MEMORANDUM
TODD THALHAMER, P.E.
TIMOTHY D. STARK, Ph.D., P.E., D.GE

Date: July 22, 2013

RE: Comments on the Draft Bridgeton Landfill North Quarry Contingency Plan – Part 1, Dated June 27, 2013

Figure 1. Approximate Location of Heat Front Based 165 °F at the Bridgeton Landfill, MO (Map Source: SCS Engineers, 2012).

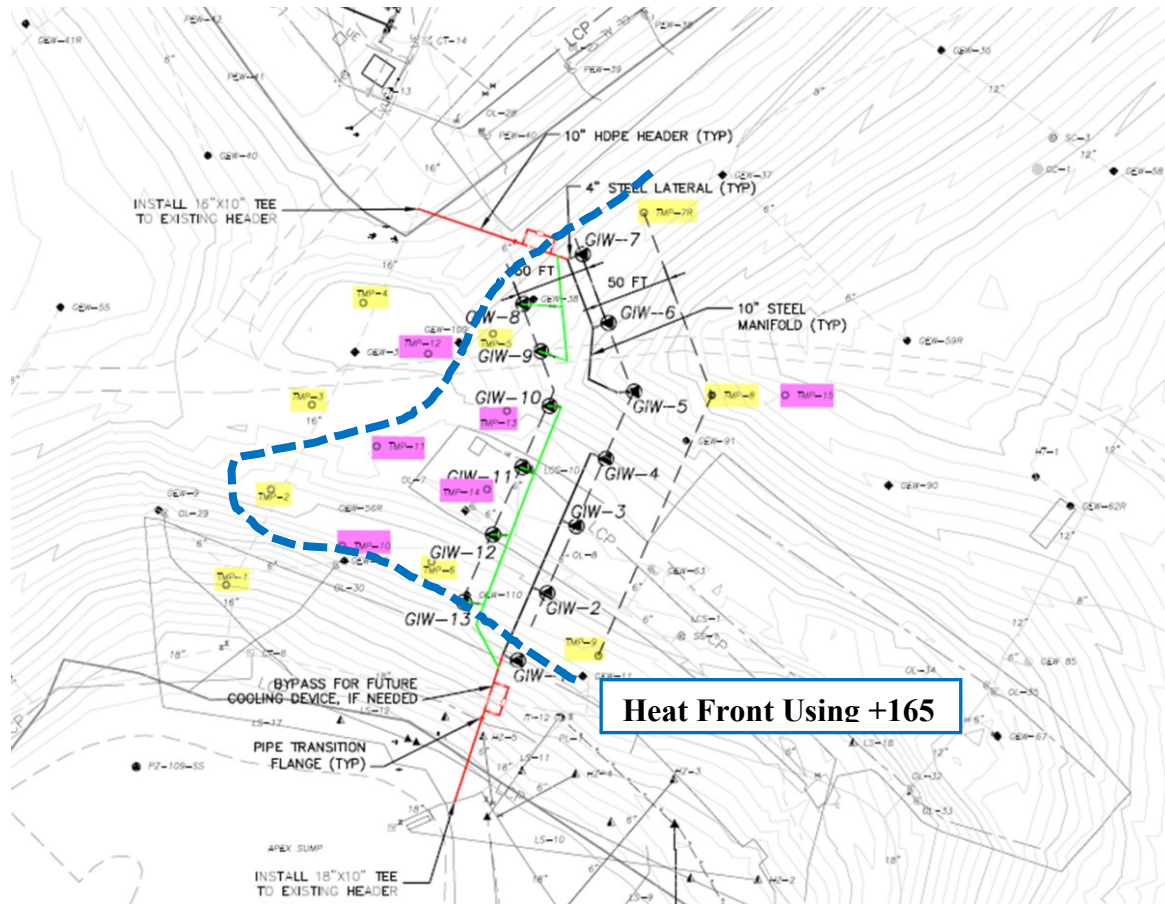
Using temperatures above 165 °F as the indicator of the heat front, the heat front has passed at least one of the farthest north Temperature Monitoring Probes (TMPs), TMP-1 to TMP-4. TMP data from May to June 2013 indicates the heat front is now at TMP-2 and impacting areas in the “neck” or narrow portion of the landfill. The heat front may also be impacting the North Quarry; however until additional TMPs are installed in the North Quarry and/or additional data is collected over time one can only estimate the location of the heat front.

Figure 2. Approximate Area of the Smoldering Event (SE) and CO Line above 1,500 ppm at the Bridgeton Landfill, MO (Map Source: SCS Engineers, 2012).

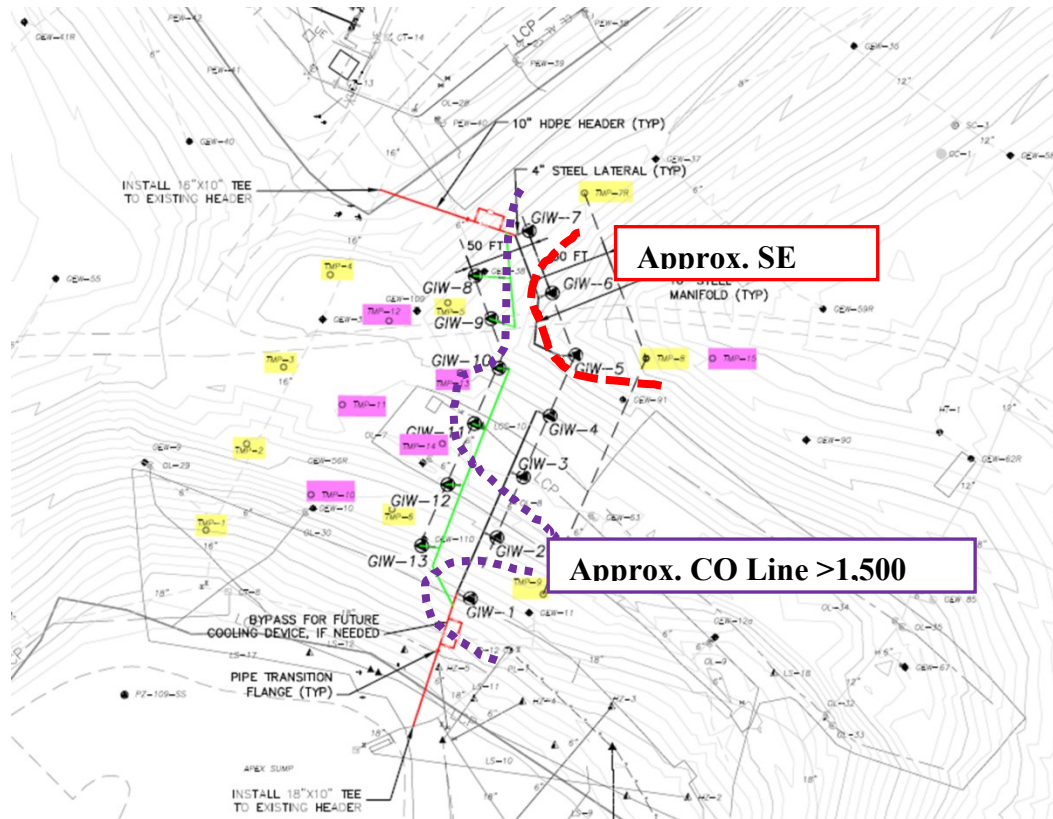
As to the location of the smoldering front(s) with respect to the “neck” and North and South Quarries, the smoldering event appears to be contained in the South Quarry in between GIW-5 to GIW-6 and GIW-8 and GIW-10. Additional carbon monoxide (CO) data over time is required to determine the most probable location(s). We understand that Republic Services has agreed to provide carbon monoxide data in future months for the wells in the neck and North Quarry in addition to the information presently provided for gas extraction wells in the South Quarry. Figure 1 shows the approximate location of the heat front in the neck using TMP data from May to June 2013, while Figure 2 shows the approximate location of the smoldering event(s) based on the CO results from June 7, 2013. Both digital captures are from SCS Engineers, Well Layout Plan, dated January 10, 2013. To better understand the spatial complexity of these reactions, a cross section of the neck was prepared (Stark 2013). Figure 3 shows the approximate location of both the heat and smoldering fronts as it relates to the GIW and TMP systems as of April 2013.
